# **UN/SCETDG/49/INF.4/Add.4**

## **UN/SCEGHS/31/INF.3/Add.4**

**Revision of the Manual of Tests and Criteria:  
Parts III, IV and V (Chapters 30 to 51)**

**Transmitted by the Chairman of the Working Group on Explosives on  
behalf of the Working Group**

Figure 32.5.2.1: COMBUSTIBILITY TESTER

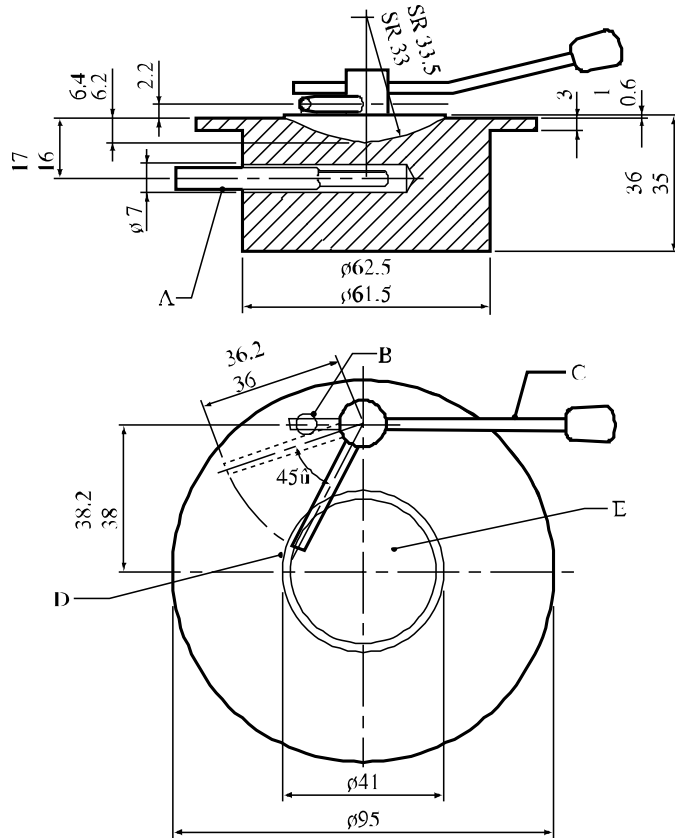
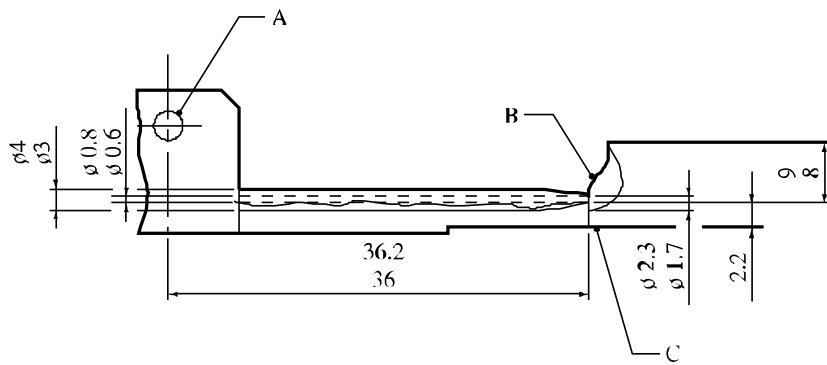
gas jet assembly on a swivel is attached to the block. The handle and gas inlet for the gas jet may be fitted at any convenient angle to the gas jet. ~~A suitable apparatus is shown in Figure 32.5.2.1 and the e~~Essential diagrams ~~for a suitable apparatus~~ are given in figures 32.5.2.1 and 32.5.2.2. The following apparatus is also required:

Figure 33.2-4.3 : FLOW CHART FOR CLASSIFICATION OF ASSIGNING READILY COMBUSTIBLE FLAMMABLE SOLIDS, EXCEPT METAL POWDERS, TO DIVISION 4.1

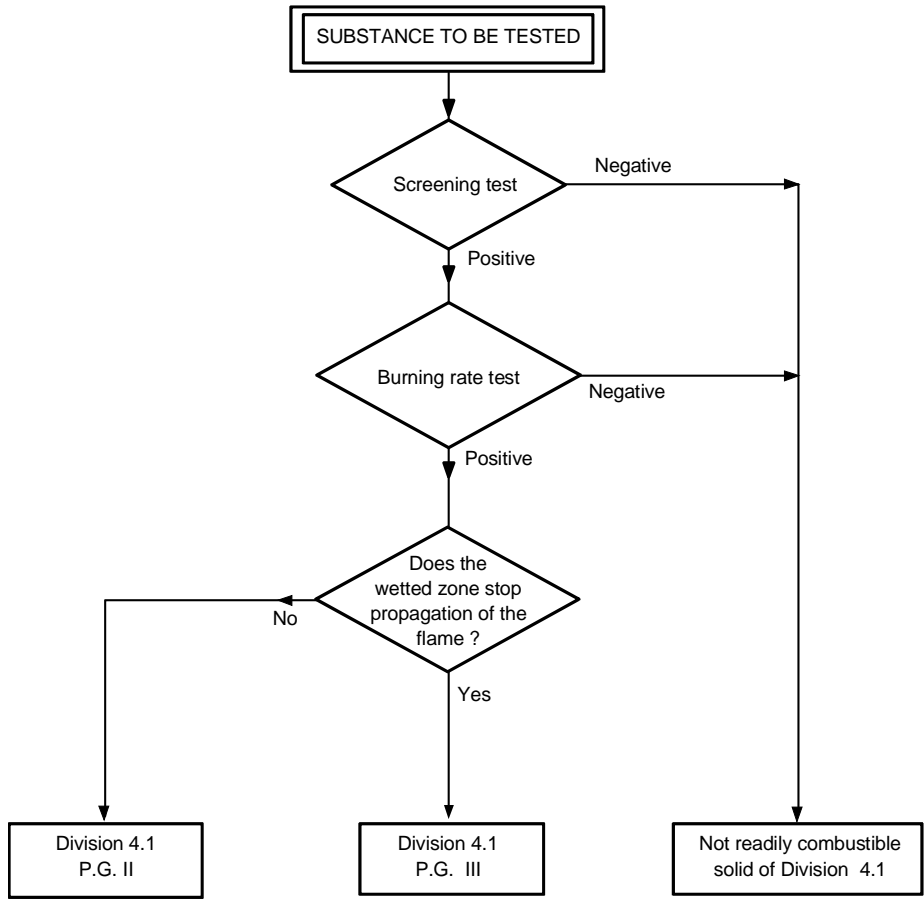
~~33.2.1.1~~ Section ~~33.2.1.3~~ presents the United Nations scheme for the classification of readily combustible solids of Division 4.1 (see [Chapter 2.4](#), sub-section 2.4.2.2 of the Model Regulations and Chapter 2.7 of the GHS). The text should be used in conjunction with the classification principles given in [Chapter 2.4](#), paragraphs 2.4.2.2.2 and 2.4.2.2.3 of the Model Regulations, [Chapter 2.7, paragraph 2.7.2 of the GHS](#), the flow chart given in Figure ~~33.2.1.3~~ and the test prescription given ~~here~~ in ~~33.2.1.4~~.

~~33.2.1.3.1~~ A preliminary screening test is performed to determine if, on ignition by a gas flame, propagation by burning with flame or smouldering occurs. If propagation occurs within a specified time then the full test is carried out to determine the rate and vigour of burning.

~~33.2.1.3.2~~ The tests should only be applied to granular, paste-like or powdery substances. If in the screening test, the substance does not ignite and propagate combustion either by burning with flame or smouldering, it is not necessary to perform the complete burning rate test as the substance is not a readily combustible solid ~~of Division 4.1~~. If propagation occurs and the burning time is less than a specified time, the full burning rate test should be performed. Whether the substance is a ~~readily combustible~~ flammable solid ~~of Division 4.1~~ and, if so, whether packing group II / [Category 1](#) or III / [2](#) should be assigned is decided on the basis of the test result.

Figure 33.3.1-33.5.3.3.1: CLASSIFICATION OF SELF-HEATING SUBSTANCES

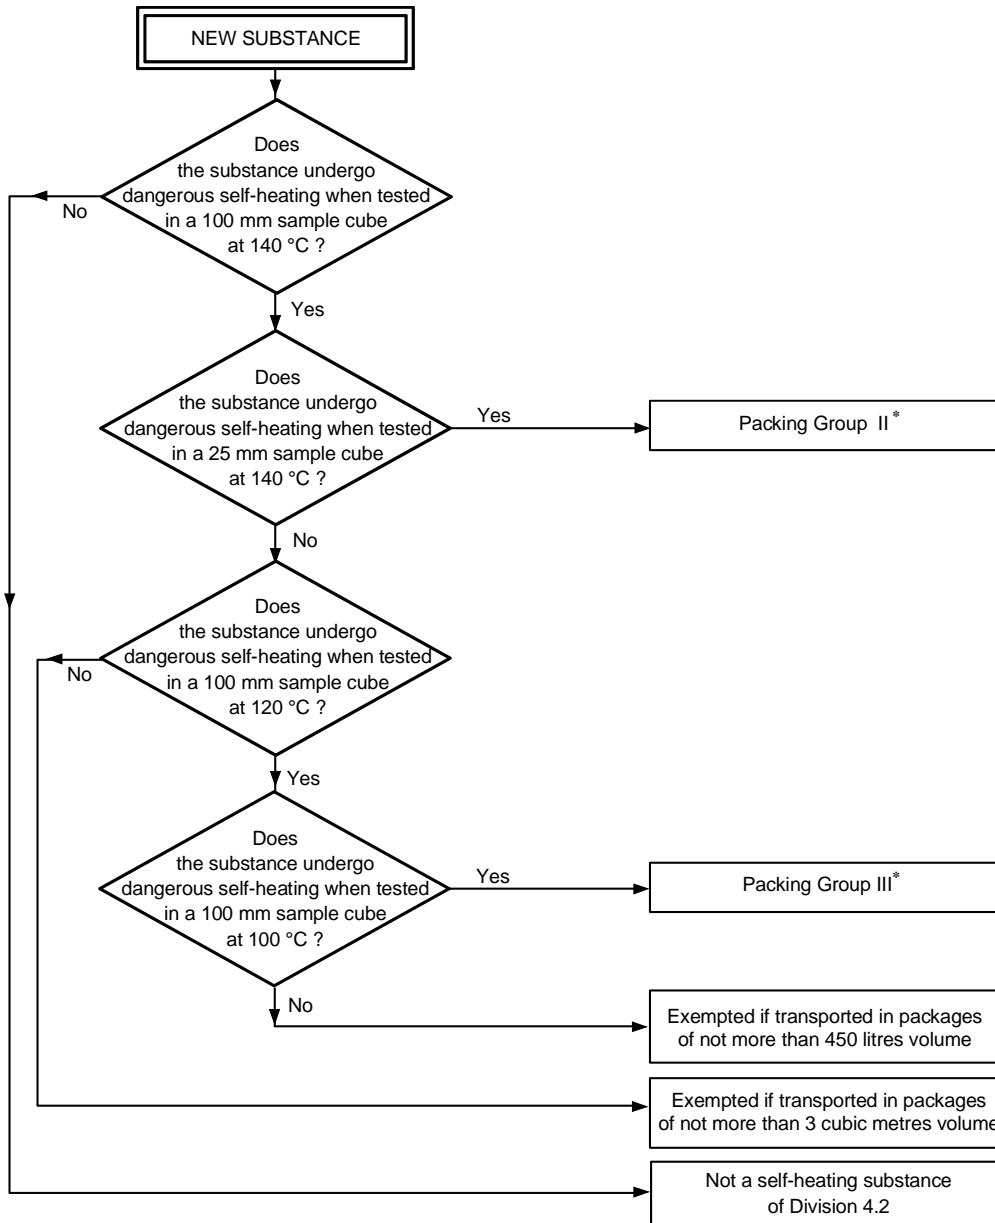
~~33.3-133.5.3.3.1~~ 33.5.3.3.1 Tests are performed to determine if substances in a 25 mm or 100 mm sample cube, at test temperatures of 100 °C, 120 °C or 140 °C, undergo spontaneous ignition or dangerous self-heating, which is indicated by a 60 °C rise in temperature over the oven temperature within 24 hours. The classification scheme is illustrated in Figure ~~33.3-133.5.3.3.1~~. These criteria are based on the self-ignition temperature of charcoal, which is 50 °C for a sample cube of 27 m<sup>3</sup>. Substances with a temperature of spontaneous combustion higher than 50 °C for a volume of 27 m<sup>3</sup> should not be classified as a self-heating substance assigned to Division 4.2. Substances with a spontaneous ignition temperature higher than 50 °C for a volume of 450 litres should not be assigned to packing group II / Category 1 of Division 4.2. The recommended test method is given ~~here~~ in ~~33.3-133.5.6~~.

~~33.3-133.5.3.3.5~~ 33.5.3.3.5 Self-reactive substances type G which give a positive result ~~with-in~~ this test ~~method~~ may be classified as self-heating substances in Division 4.2 (see 20.2.6).

**Comment [Ed8]:** there are other experiences that seems to contradict this
